# CITY OF ALBUQUERQUE

**RE: 10538 Dover St. NW**  
**2<sup>nd</sup> Revised Grading and Drainage Plan**  
**Engineer's Stamp Date: 06/07/22**  
**Hydrology File: A12D031**

Based upon the information provided in your submittal received 06/06/2022, the 2<sup>nd</sup> Revised Grading and Drainage Plan is approved for Building Permit. Please attach a copy of this approved plan in the construction sets for Building Permit processing along with a copy of this letter.

ENGINEER'S SEAL	10538 DOVER	DRAWN BY WCVJ
	GRADING AND DRAINAGE PLAN	DATE 8-21-19
		2109068-LAYOUT-8-21-19
DAVID SOULE P.E. #14522	 1606 CENTRAL AVENUE SE SUITE 201 ALBUQUERQUE, NM 87106 (505) 872-0998	SHEET #
		JOB # 2109068

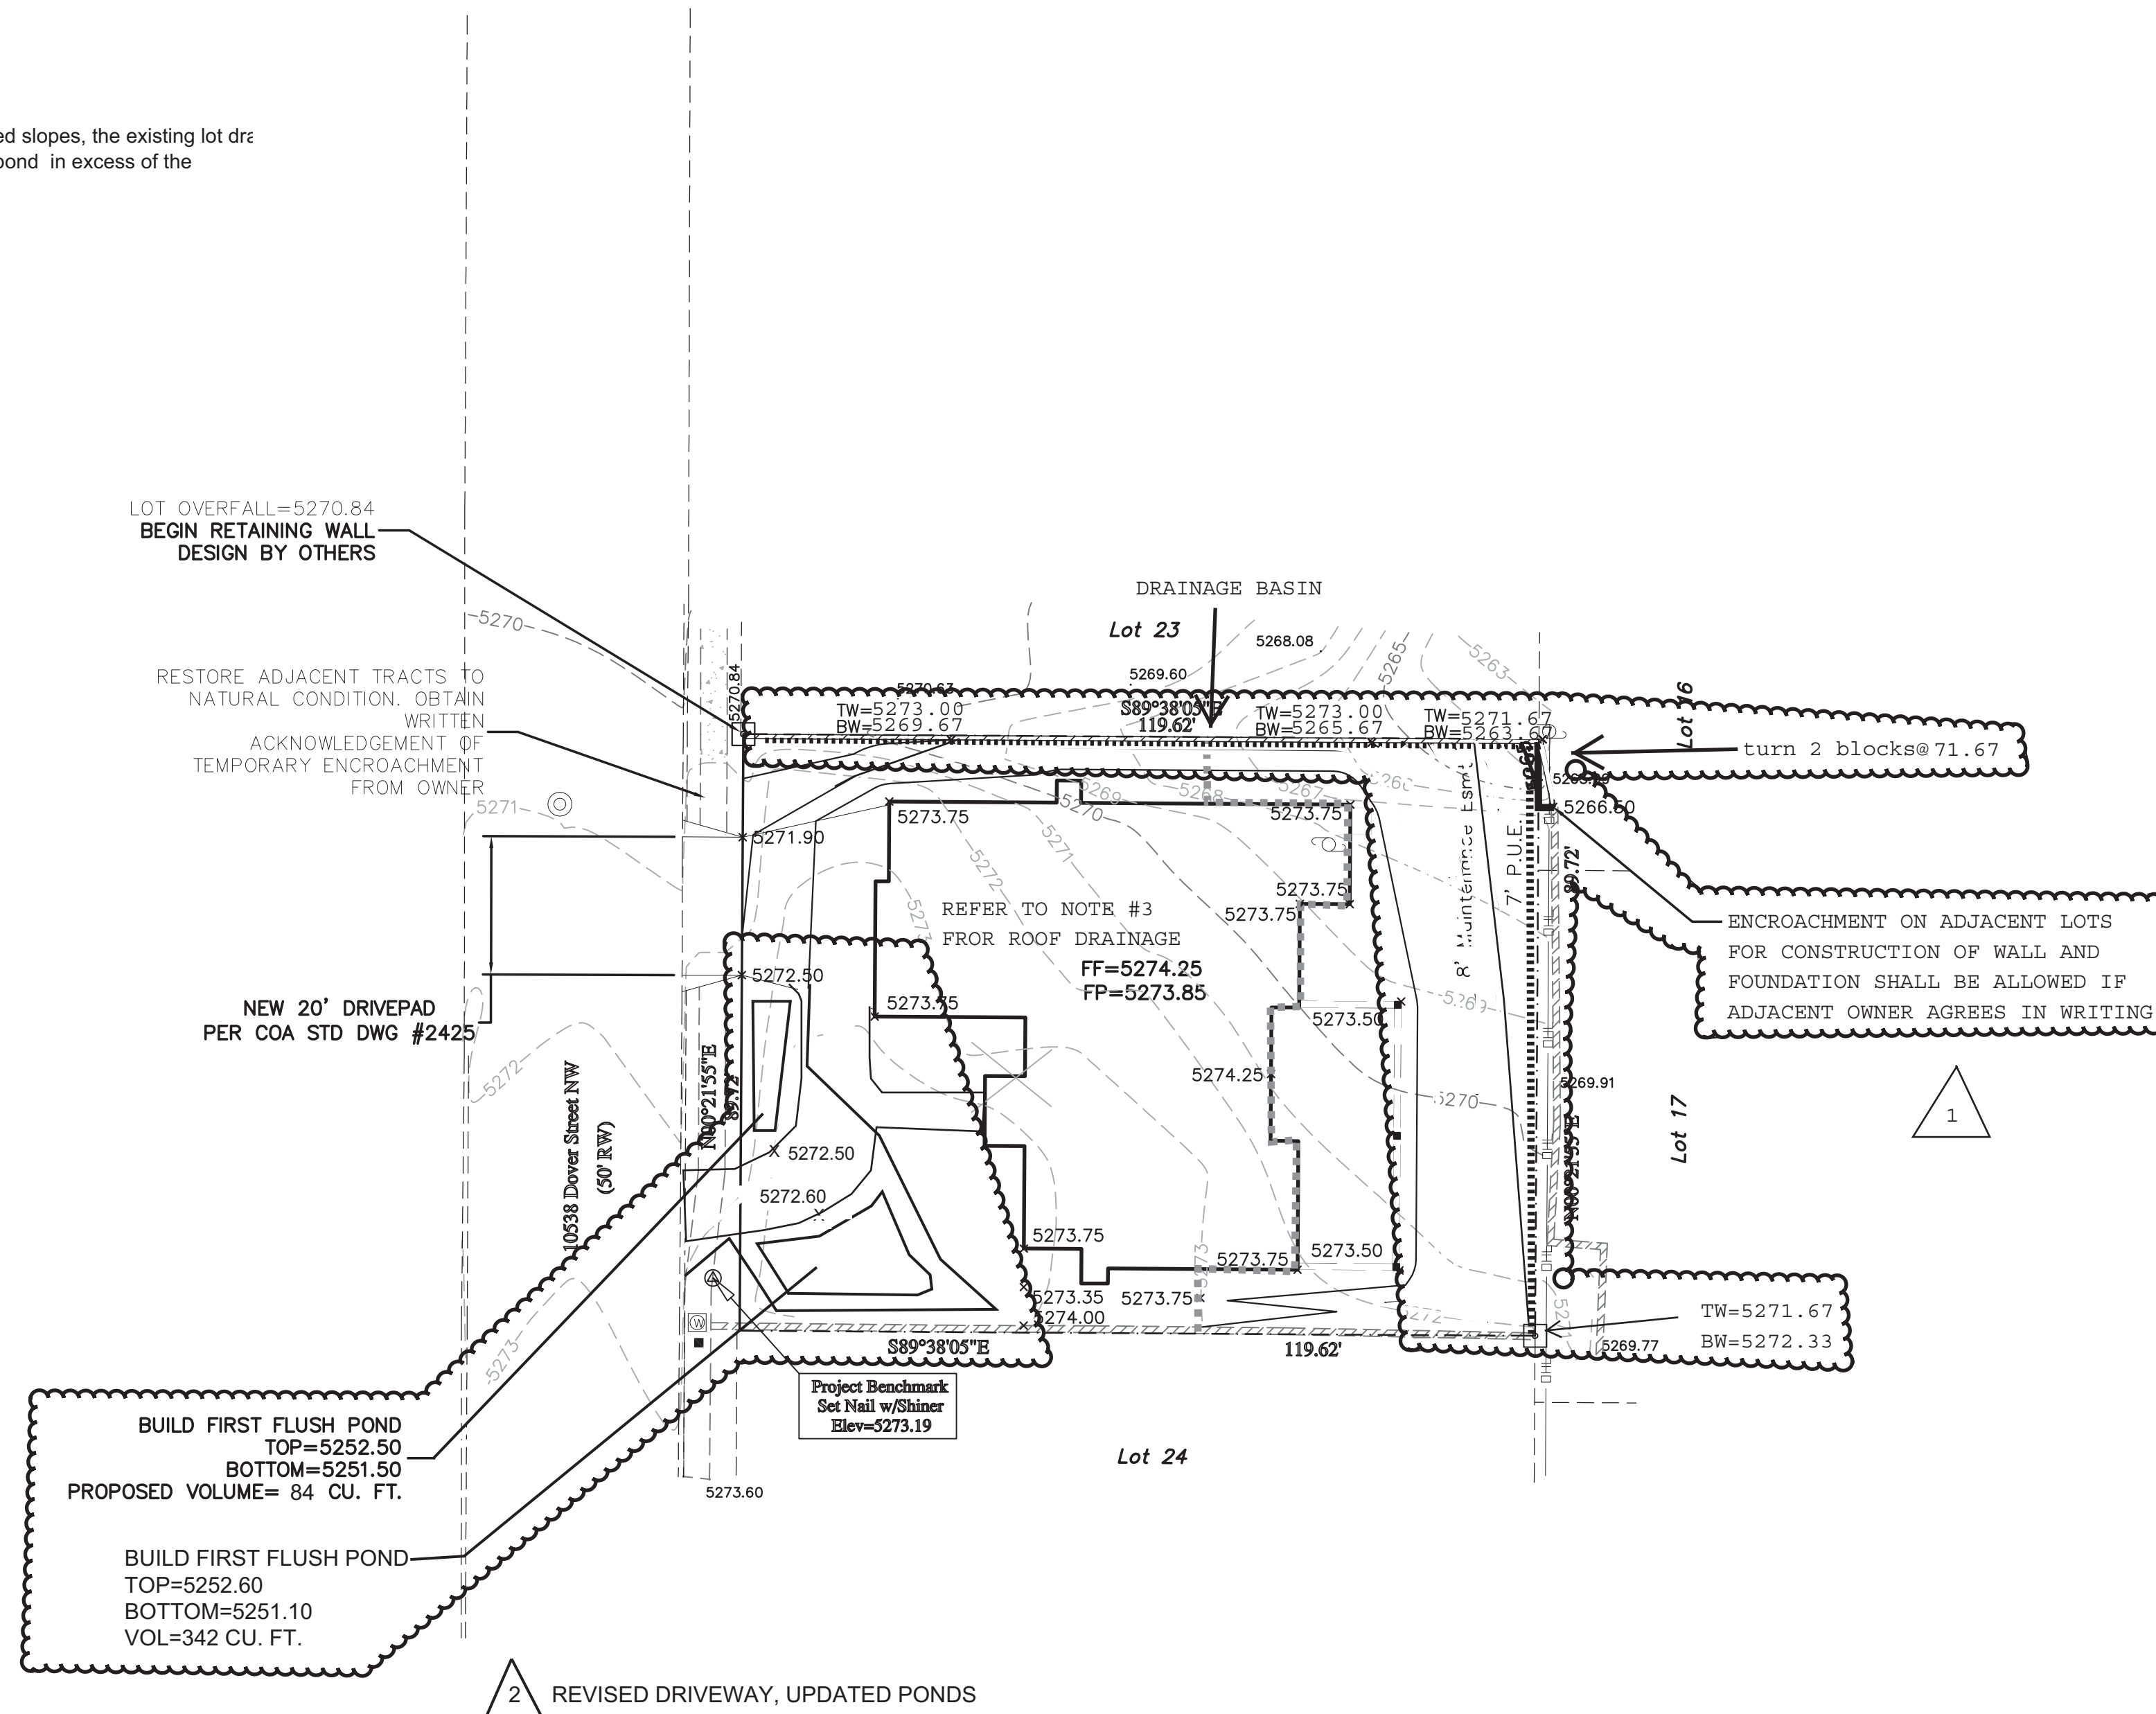
1. Engineer's Certification, per the DPM Part 6-14 (G): Engineer's Certification Checklist for Subdivision and Part 6-14 (H): Required Certification Language is required.
